# RENESAS TECHNICAL UPDATE

| Product<br>Category   | MPU&MCU   |          | Document<br>No.         | TN-SH7-A663A/E  | Rev. | 1.00 |
|-----------------------|---|----------|-------------------------|---|------|------|
| Title                 | Note on use of SH7780 PCIC Host Bus Bridge Mode and Manual Correction |          | Information<br>Category | Technical Notification  |      |      |
| Applicable<br>Product | SH7780 Group  | Lot No.  |                         | SH7780 Hardware Manual<br>Rev.1.00 Dec.13.2005<br>(REJ09B0158-0100) |      |      |

Figure. Example of REQ# Negation and FRAME# Assertion are not Same Clock Timing

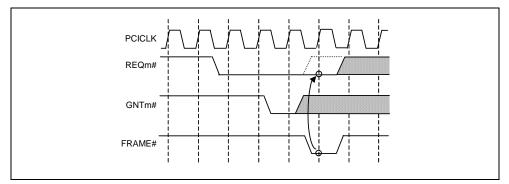
When using the PCIC in host bus bridge mode with the following condition (1) to (4) all, the PCI bus request from the device of lower priority REQn# (#: low active) than REQm# (n>m) may be masked in the PCIC, and the PCI bus arbitration may not be performed correctly. And even if the lower priority device keeps asserting its REQn#, the corresponding GNTn# is not asserted, as the result, the transfer request of the REQn# device is not executed and then the master broken error of the REQn# device (PCIAINT.MBI=1) and the REQn# error (PCIBMIR.REQnBME=1) may occur.

- (1) Selecting the PCI bus arbitration mode is fixed mode (PCICR.BMAM=0).
- (2) There are two or more external PCI devices except the SH7780 that may become a master.
- (3) There is at least one device that does not negate the REQ# on the same clock timing of the FRAME# assertion (the REQ# negation is one or more clock later than the FRAME# assertion \*1) when a transaction (single and burst transfer) is executed. (REQm# in the following figure)
- (4) There is an external PCI device that may become a master and has the lower priority (REQn#) than the above device (REQm#).

Note \*1: It is not included that the REQ# is asserted continuously for a next transaction.

An external PCI device that does not negate the REQ# on the same clock timing of the FRAME# assertion (REQm# in above figure) may become a master; use the following workaround either (1) or (2).

(1) Use pseudo round robin mode for arbitration.

Select pseudo round robin mode for the PCI bus arbitration (PCICR.BMAM-1). When using round robin mode, the REQn# is not masked in the PCIC and the PCI bus arbitration is performed correctly.

(2) The priority of the corresponding timing device (REQm# in above figure) is made the lowest priority.

In case of only one device that does not negate the REQ# on the same clock timing of the FRAME# assertion, made the priority level of the corresponding device to lowest (connect the corresponding device to the lowest REQn# and GNTn#).
